AGENDA REPORT

MEETING DATE:	November 16, 2026	Regular
DEPARTMENT:	City Manager	Steven Krokoff, City Manager Steven Krokoff Steven Krokoff (Nov 12, 2026 17:18:08 EST)
SECTION OF AGENDA:	New Business	November 16, 2026
AGENDA ITEM TITLE:	Consideration of an Addendum to the Purchase and Sale Agreement dated September 21, 2026, regarding the acquisition of the Verizon Place property regarding Tower Approvals.	
STATEMENT OF PURPOSE:	To approve the tower locations and satisfy the City's contractual tower-approval obligations, contingent upon closing and conveyance to the Development Authority of Milton, while establishing provisions for future access and utility/fiber easement relocation.	
FINANCIAL IMPACT:	The proposed temporary-location amendment leaves the $26,250,000 purchase price unchanged.	
RECOMMENDED ACTION:	Approve the addendum in the final form reviewed by the City Attorney and authorize the Mayor to execute it.

1. Addendum regarding Tower Approvals;
2. Exhibit H-1 Verizon One DRAN relocation plan set, including permanent site, access/utility, screening, and encroachment plans; applicable easement instruments and legal descriptions.
3. Exhibit H-2 temporary tower preliminary

SHEET NUMBER:
C1

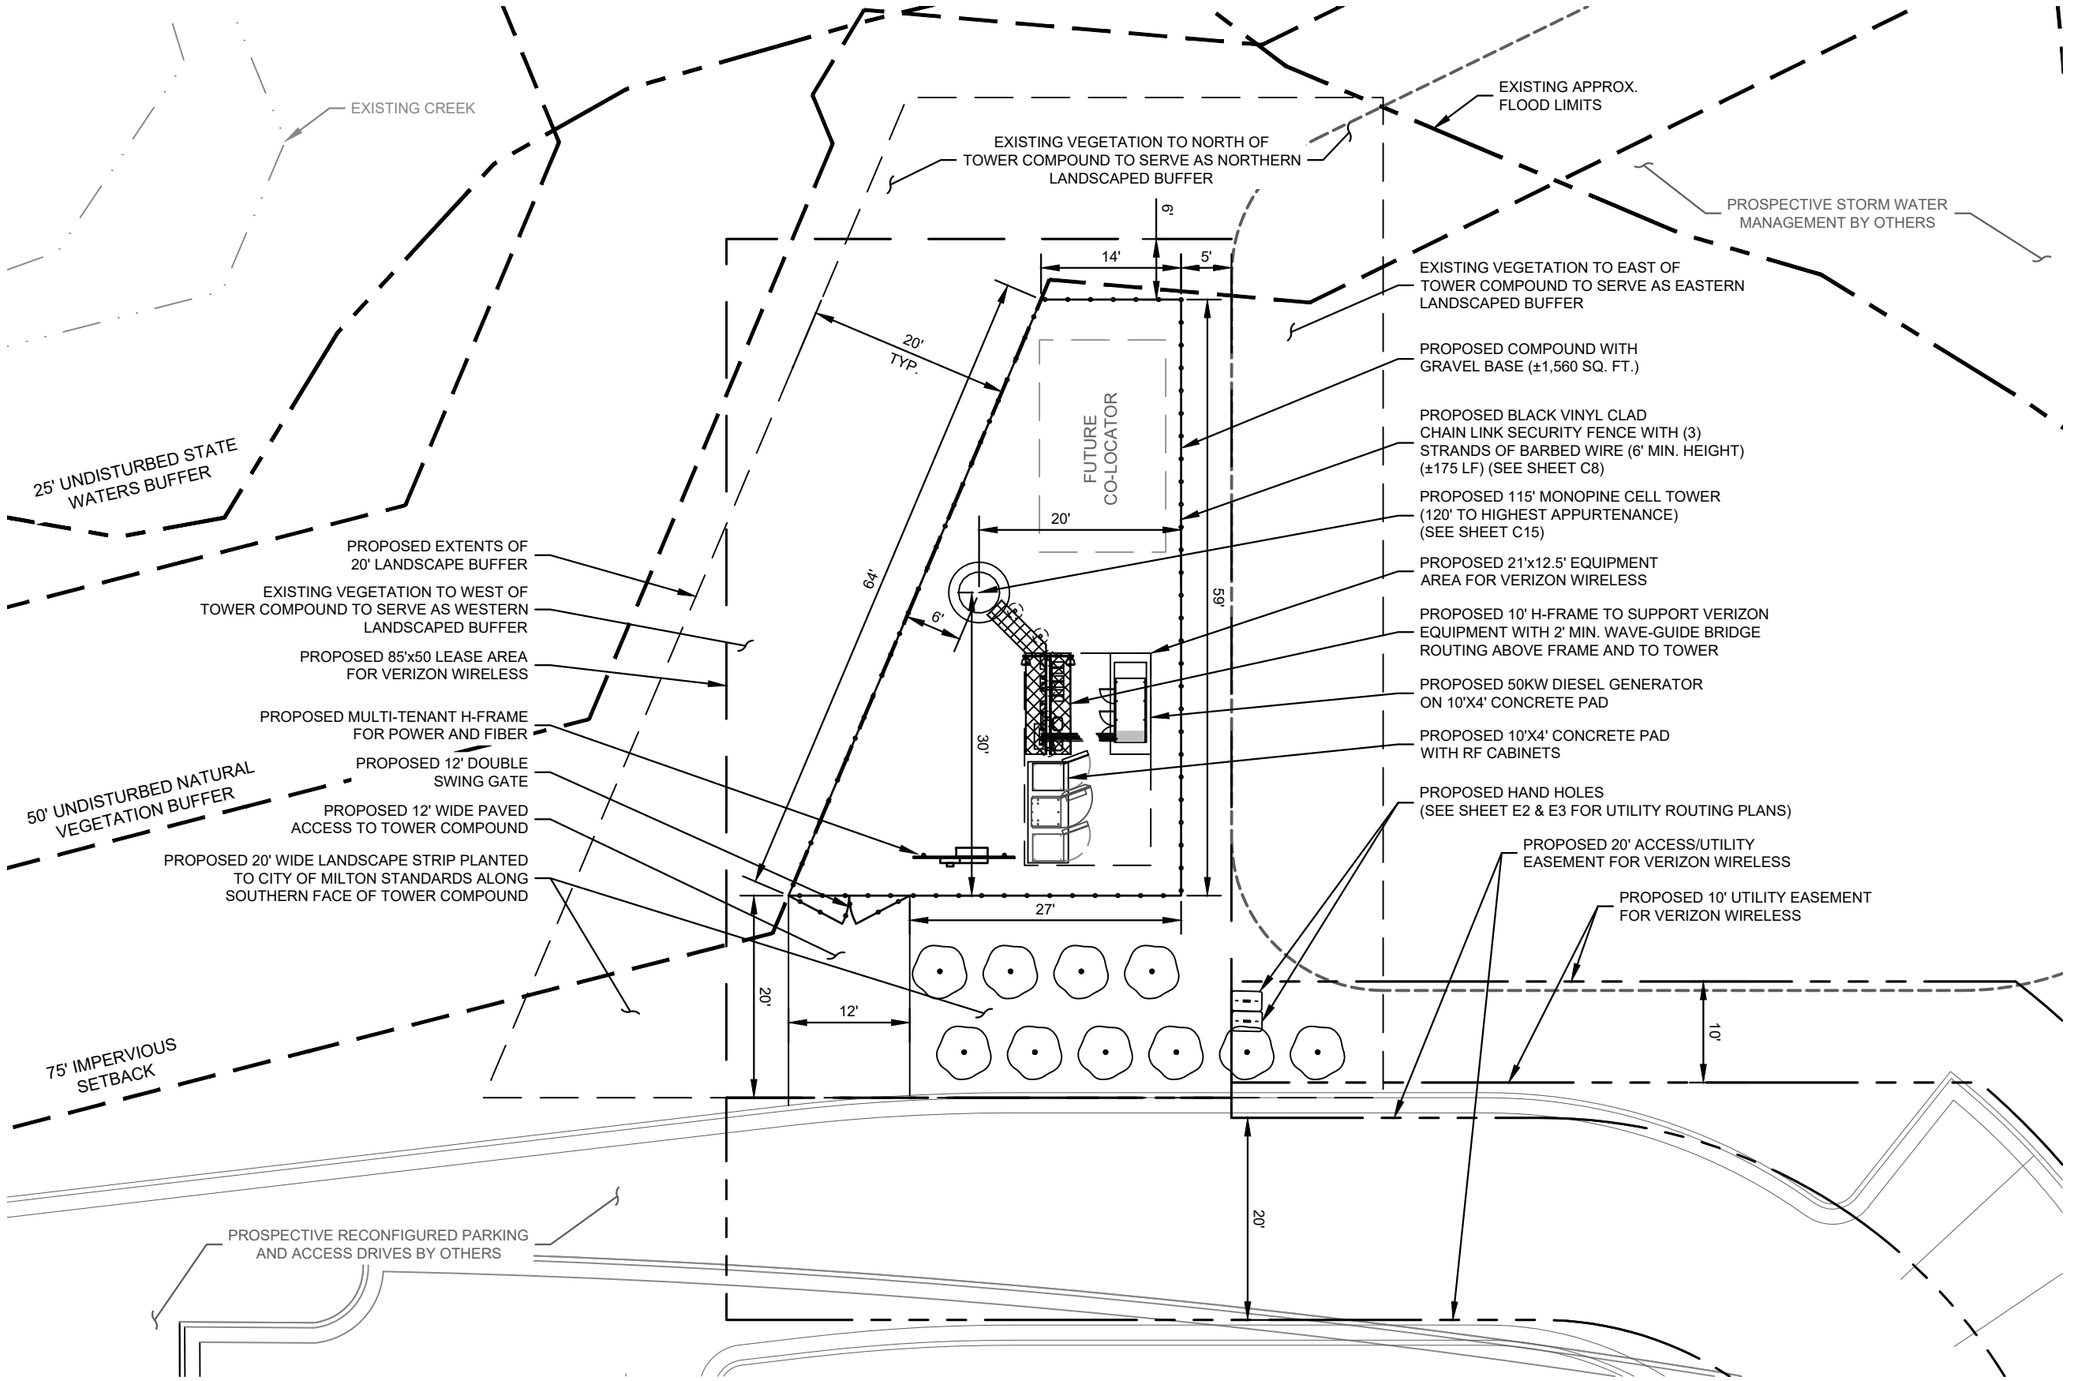
Access and utilities. Sheets C1 and C2 show a 20-foot-wide access/utility easement from the existing Morris Road apron, a separate 10-foot-wide utility easement, and a 12-foot-wide paved approach to the compound. These corridors extend beyond the tower area and must remain compatible with future roads, parking, recreation improvements, and construction access.

SHEET NUMBER:
C2

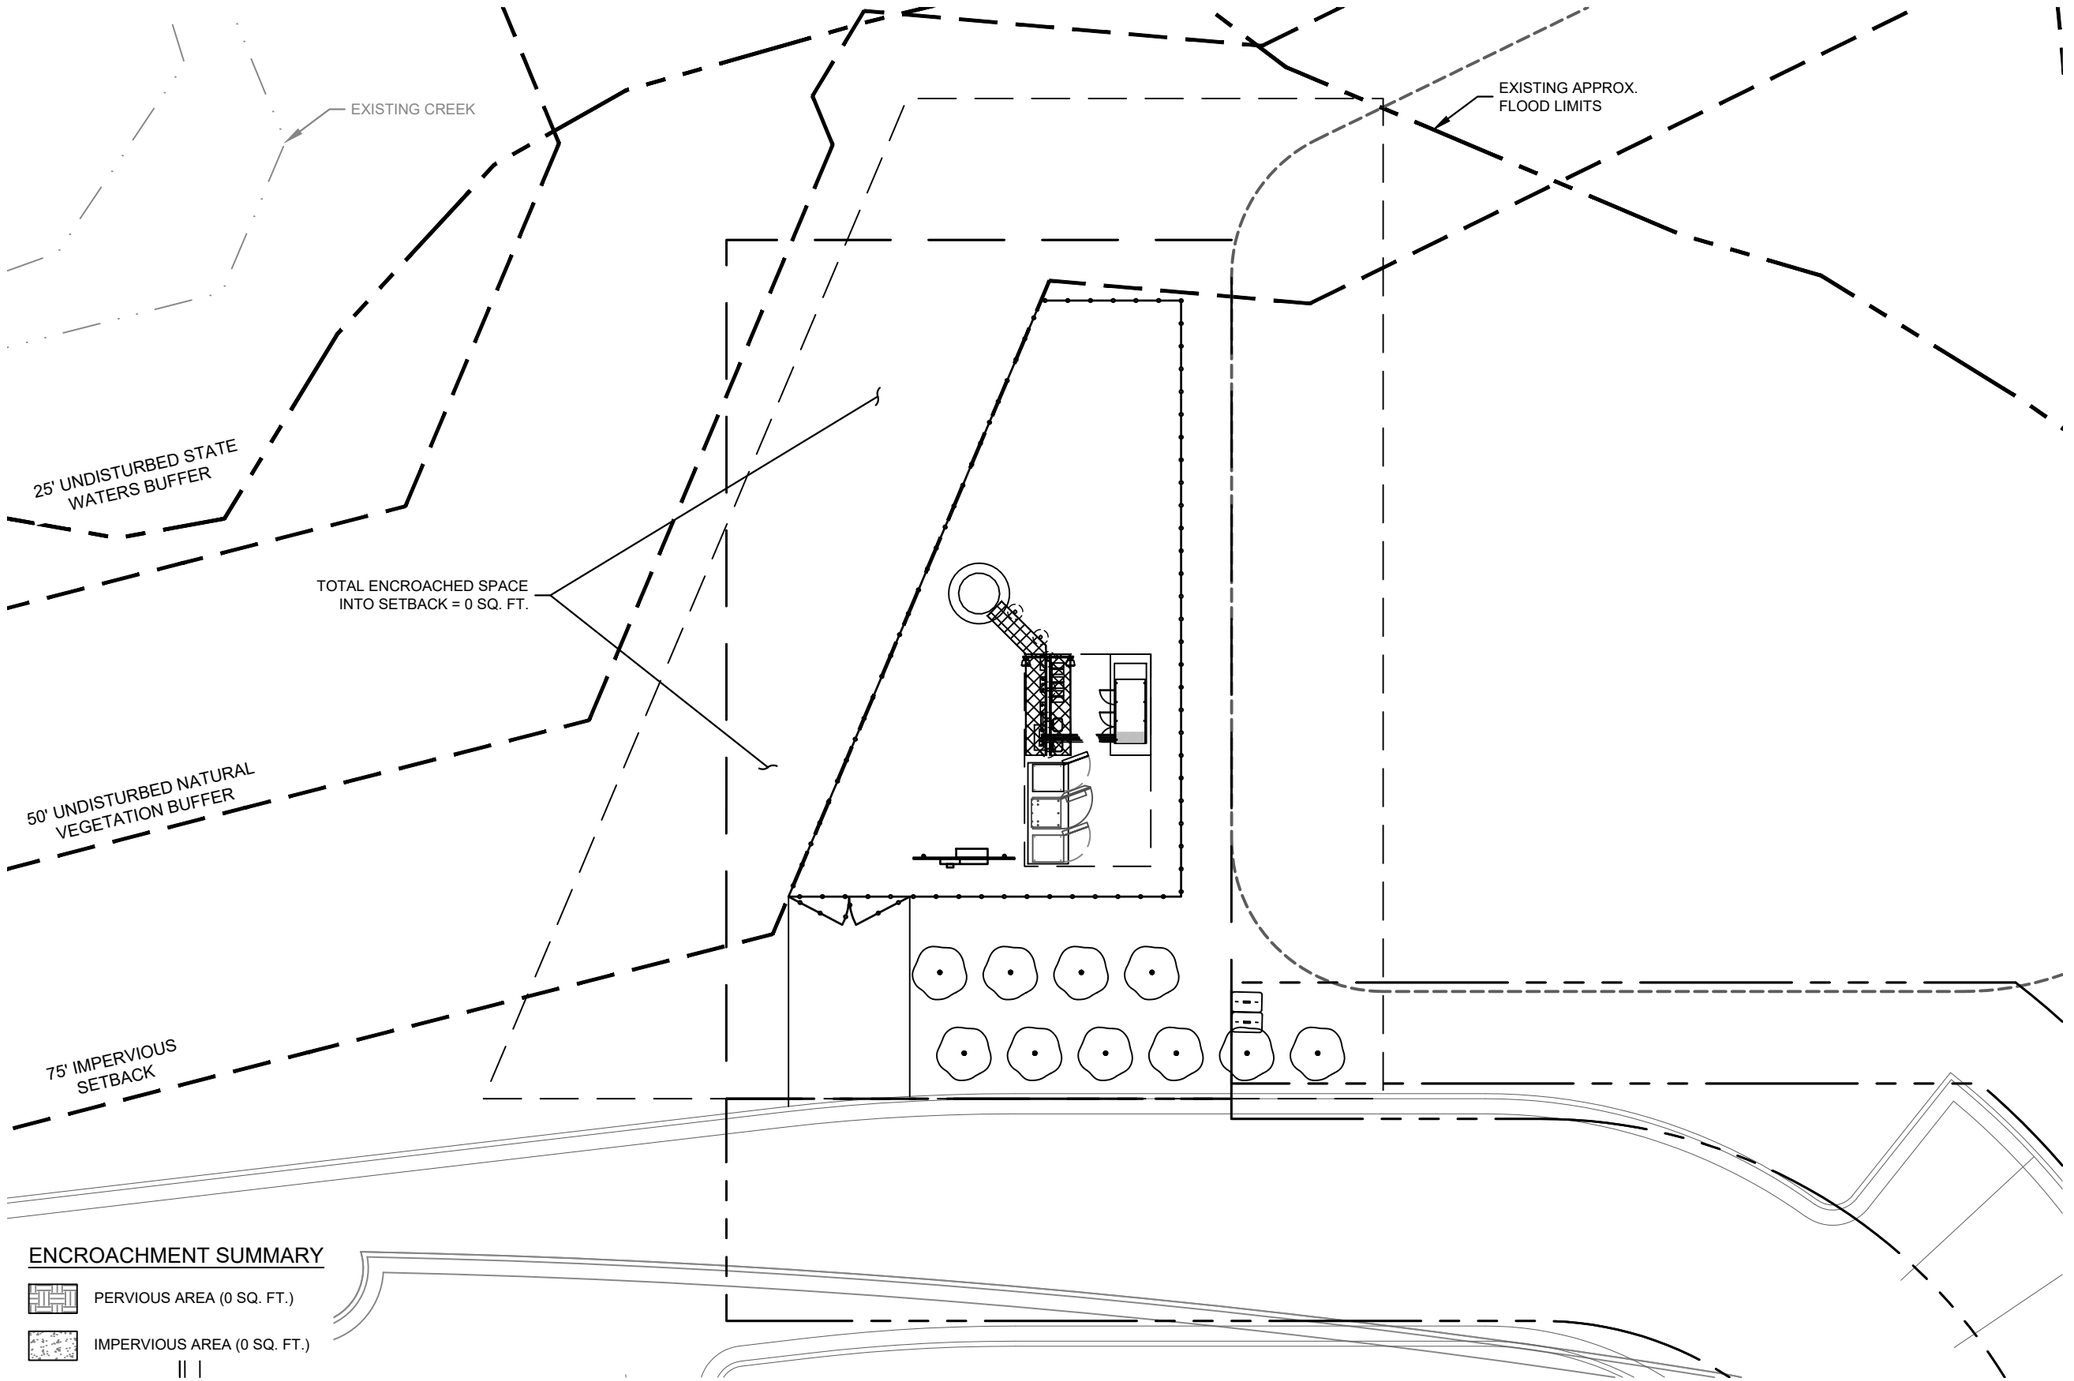
Permanent facility. The Verizon One DRAN relocation plans show a 115-foot monopine tower, 120 feet to the highest appurtenance, on the One Verizon Place parcel (tax parcel 22 544011140234). Sheet C2 labels an 85-foot by 50-foot "lease area," approximately 4,250 square feet, surrounding a gravel compound of approximately 1,560 square feet. This is separate from the temporary tower's 625-square-foot area.

Screening and equipment. Sheet C2 shows a 20-foot landscape buffer, with existing vegetation serving the north, east, and west sides and a planted strip along the south. The compound includes security fencing, a double gate, a 50-kW diesel generator, and space labeled for a future co-locator. These features warrant consideration of long-term visibility, noise, maintenance access, and potential additional use of the compound.

SHEET NUMBER:
C3

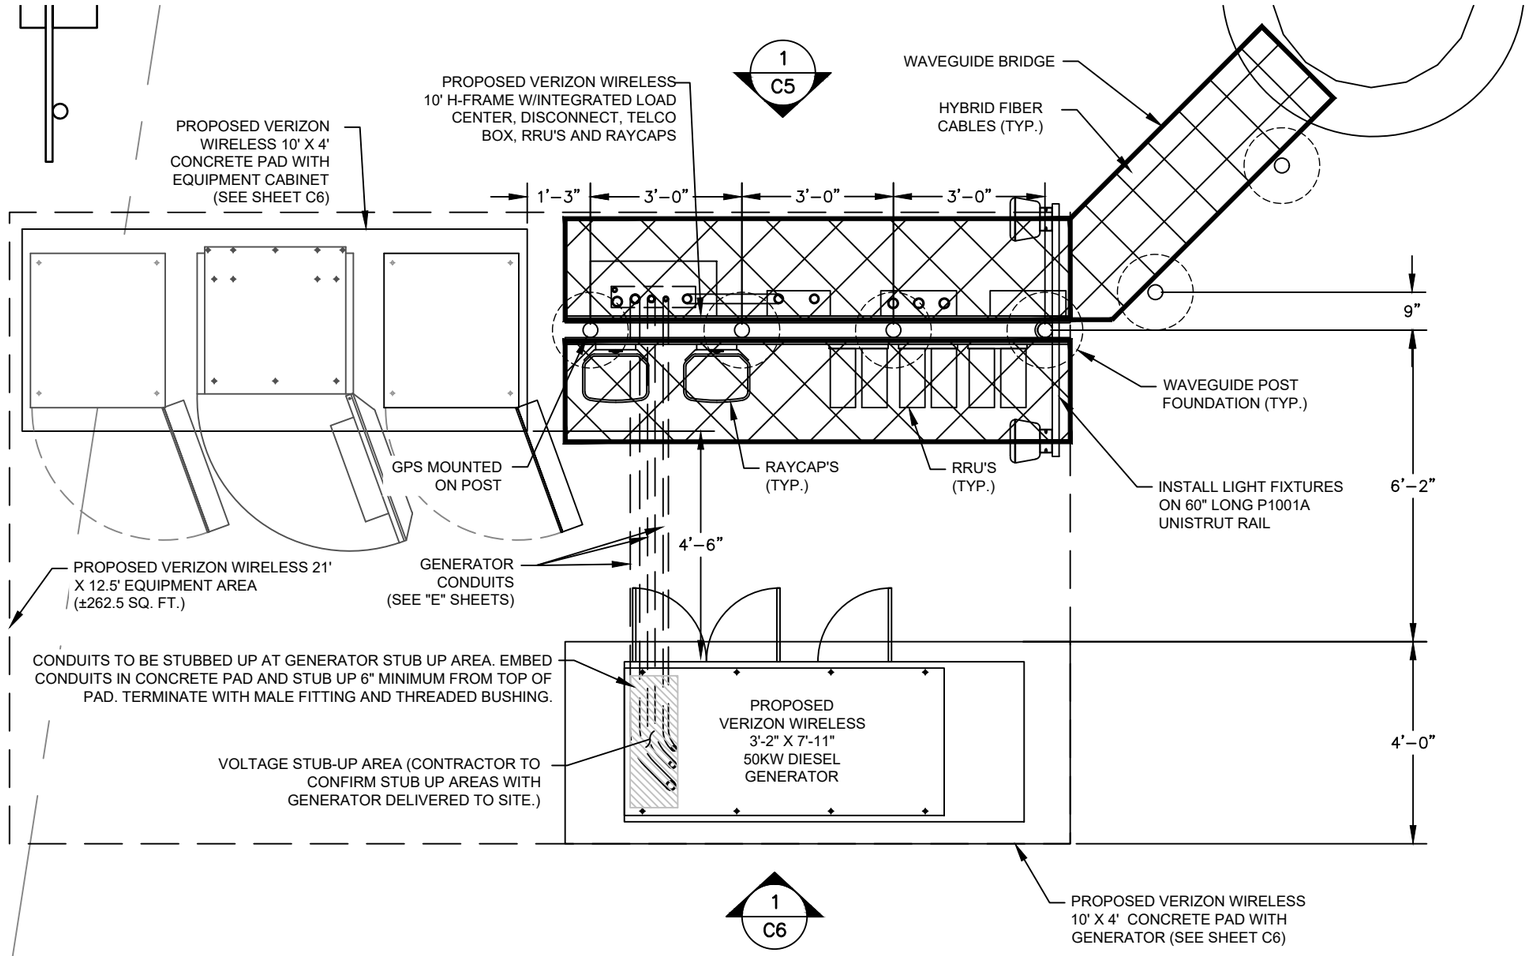
For the permanent facility, sheet C3 reports zero square feet of encroachment into the depicted setbacks and shows the creek, 25-foot state waters buffer, 50-foot natural vegetation buffer, and 75-foot impervious setback. The plans' "lease area" label and easement widths should be reconciled with the controlling legal descriptions and executed instruments; the drawings alone do not establish easement duration. Section 3(b) requires the closing easement agreement to provide that Verizon and its successors and assigns reasonably cooperate with and consent to reasonable requests to relocate or modify the access and utility/fiber easements for future development. Replacement easements must provide substantially equivalent access, utility service, capacity, and functionality, with costs assigned to the subsequent developer as described above. This provision does not address relocation of the permanent tower itself.

SHEET NUMBER:
C1

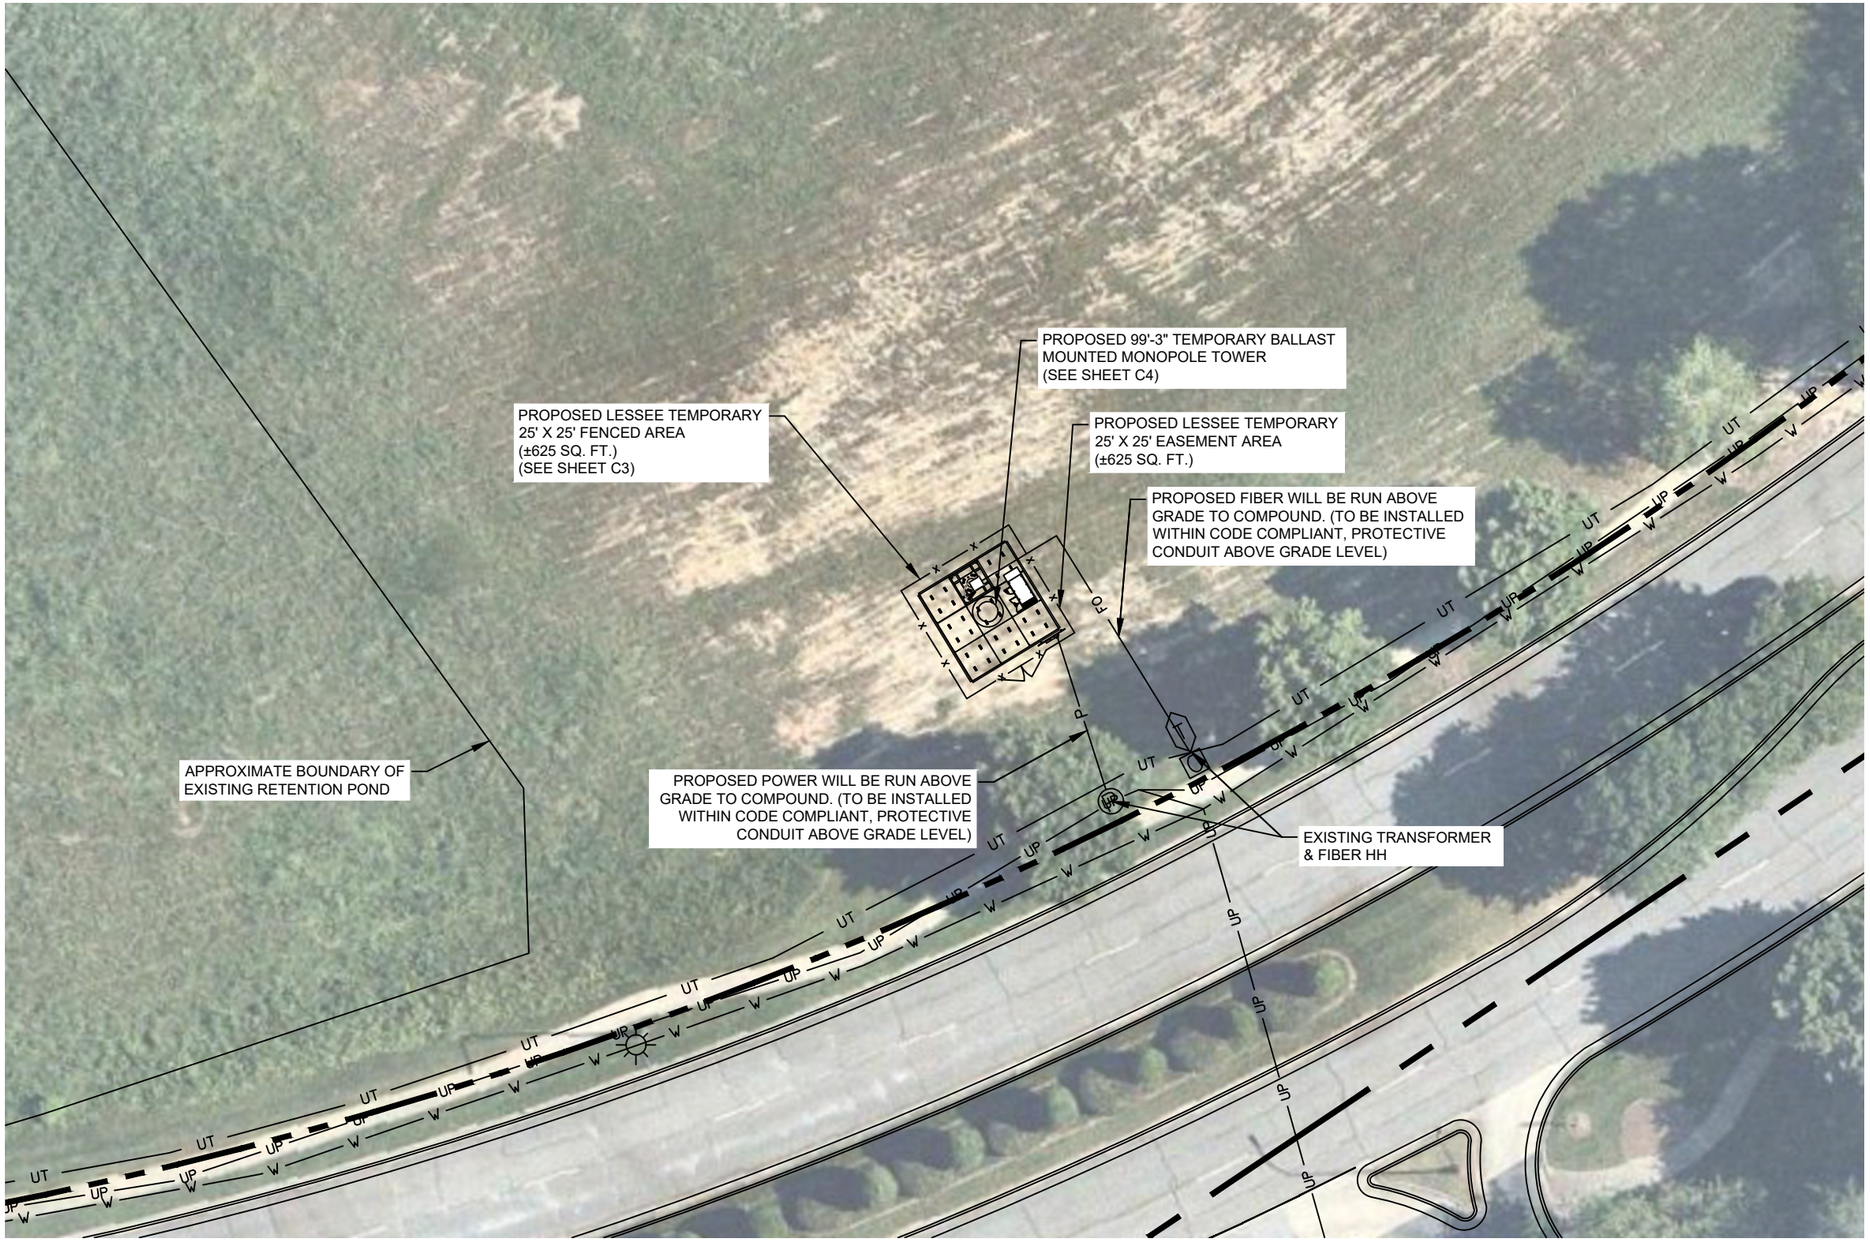
Exhibit H-2 depicts a proposed 99-foot-3-inch temporary, ballast-mounted monopole within a 25-foot by 25-foot fenced area, approximately 625 square feet, with a temporary easement of the same stated area. The compound includes a wireless equipment cabinet, equipment H-frame, temporary diesel generator, and chain-link gate (sheets C1 through C3).
